SANDMOUND SYSTEM
ON-SITE SEWAGE DISPOSAL SYSTEM
HOWARD COUNTY HEALTH DEPARTMENT
BUREAU OF ENVIRONMENTAL HEALTH

SUBDIVISION: Zubovic Property LOT NUMBER: 1

ADDRESS: 1125 Ridge Road PROPERTY OWNER: Van Knauss

SITE PLAN
LOT 1
ZUBOVIC
LIBER 5428 FOLIO 93
SITUATED ON RIDGE ROAD (MD. RTE. 27)
ELECTION DISTRICT No. 4
HOWARD COUNTY, MARYLAND
SCALE: 1" = 50' MARCH, 2002

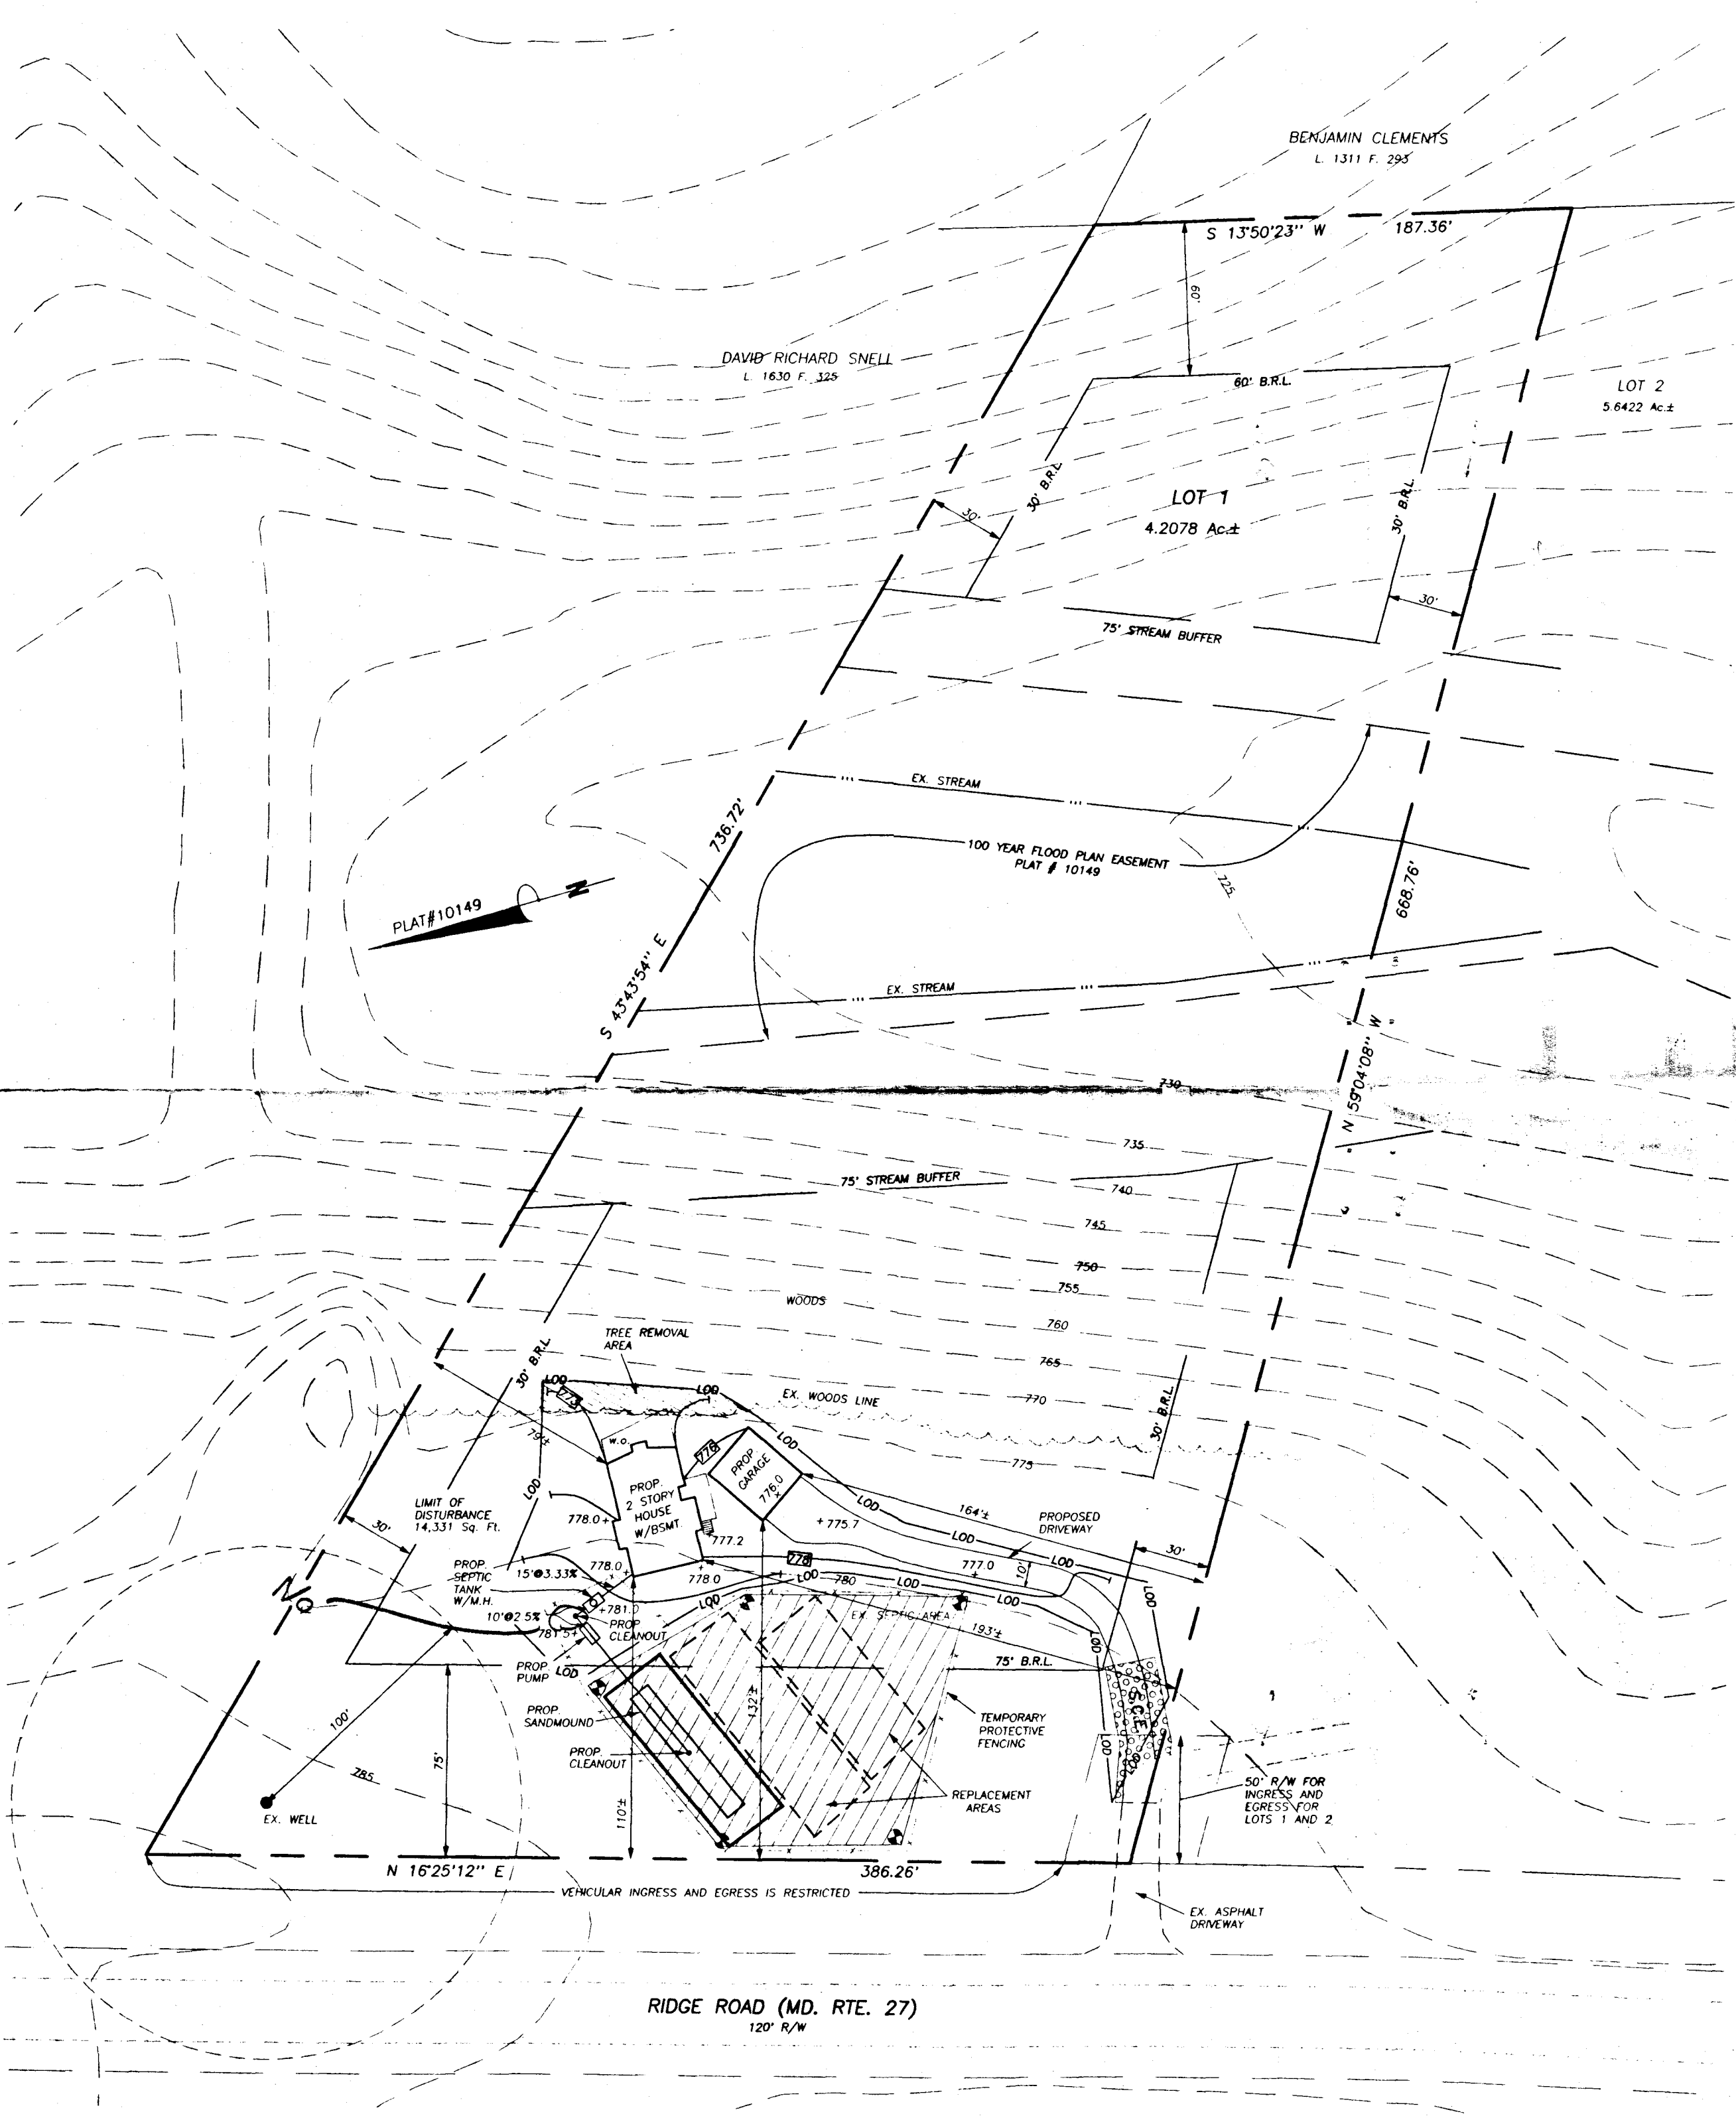
4/16/03 Contractor has same plans. Contour not as shown. Should still be able to get 3 systems in if the area towards the driveway is also used (SO)
PRE-CONSTRUCTION
4/16/03 Ground surface scratched w/ chisel disc on tractor. Sand delivered. Do they need observation ports - how many, at what depth? (SO)
INSTALLATION
4/17/03 Started, equipment broke, got a quarter completed (SO)
4/21/03 Sand completed, stone & laterals installed (SO)
4/22/03 Geotex fabric, clay cap, topsoil installed. Tanks set. (SO)
5/1/03 Pump & Alarm OK (SO)

Zubovic lot 1
A-46871

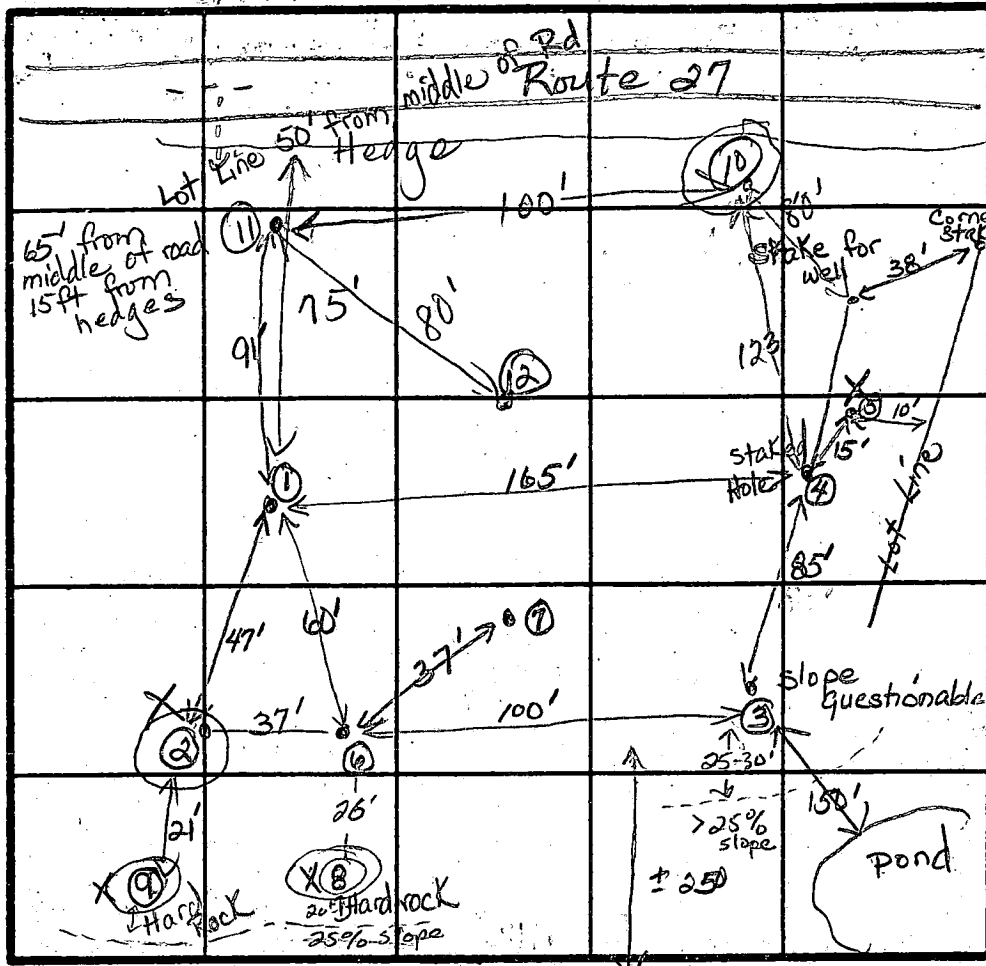
REASONS FOR REJECTION OR HOLDING 5-1-91 Recommend rejection. Shallow depths to
rock, fast percolation times, less than 7500 sq. ft. area. JEN

Zubovic
Lot-1

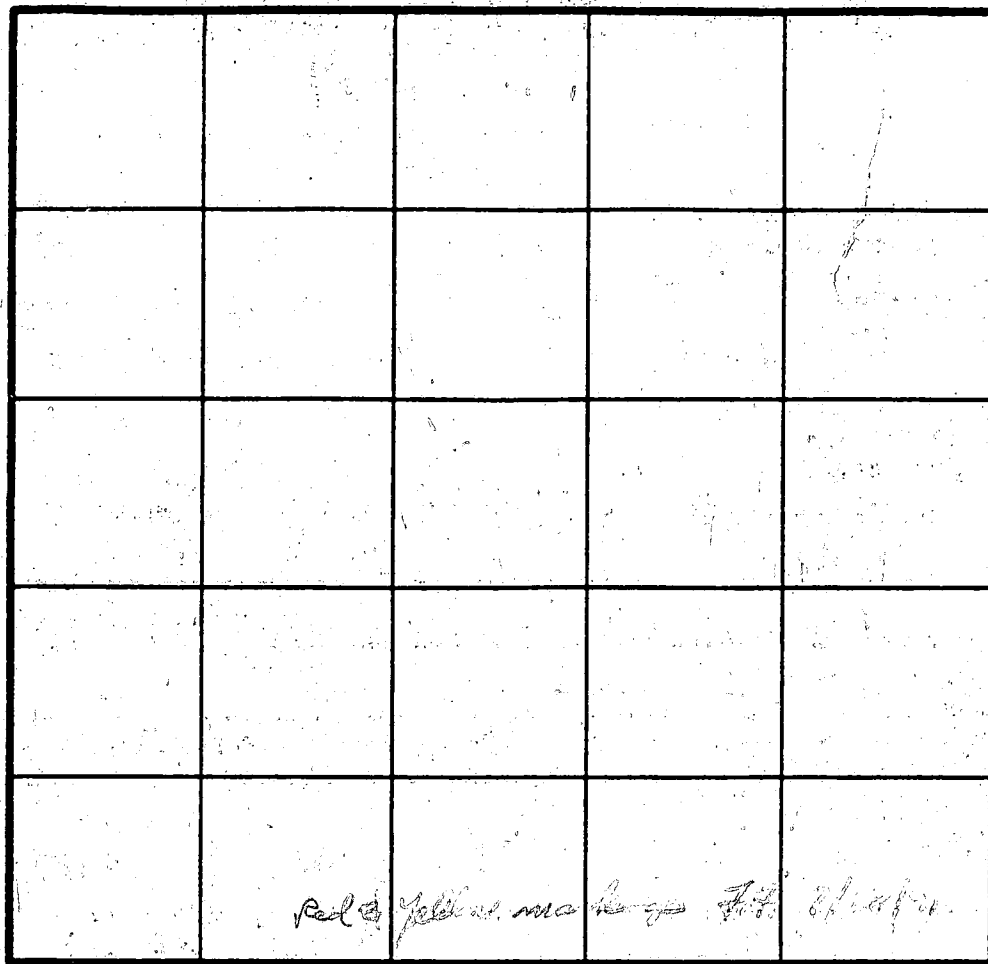
Estimate less than 7500 sq. ft. of SDA

Use holes 1, 4, 11 & 12 with shallow system,
Inlet at 1.0 ft bottom maximum at 3.0 ft.

Zubovic lot 1

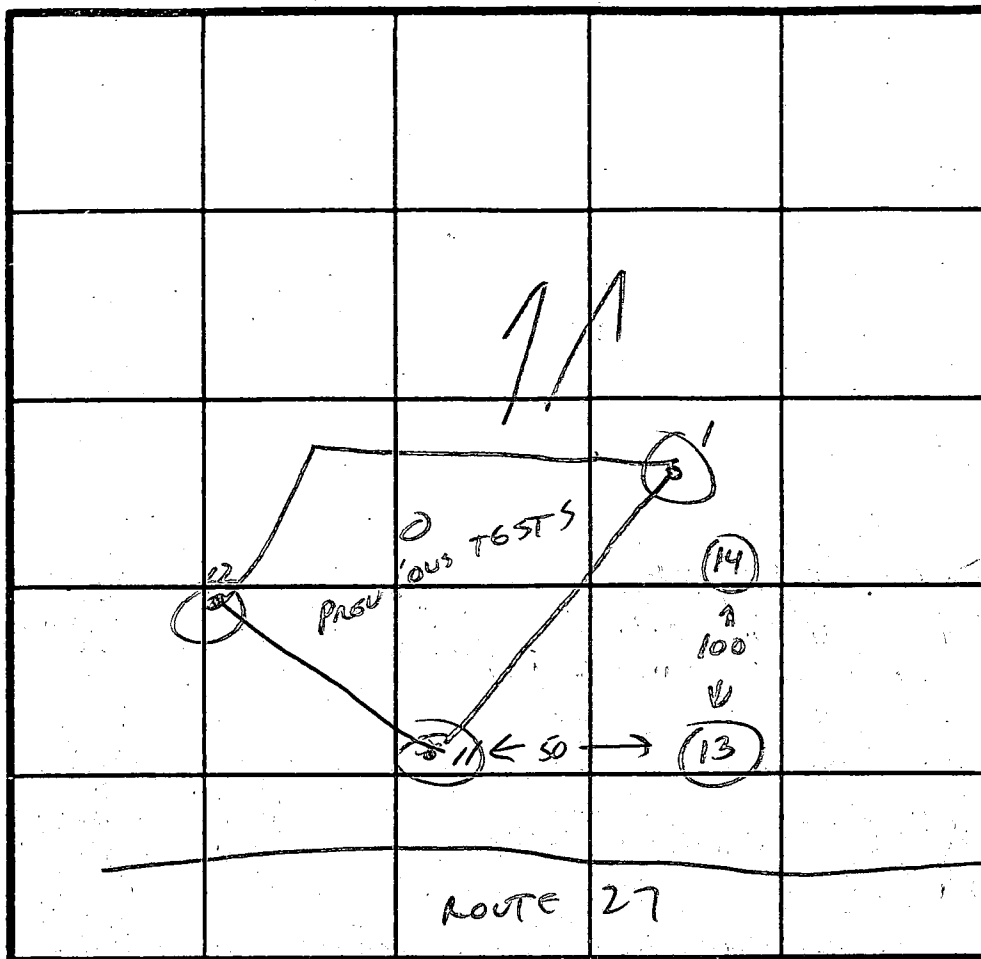
REMARKS OK TO INCLUDE TEST HOLS 13 & 14 IN TEST PATTERN, ELIMINATE # 1
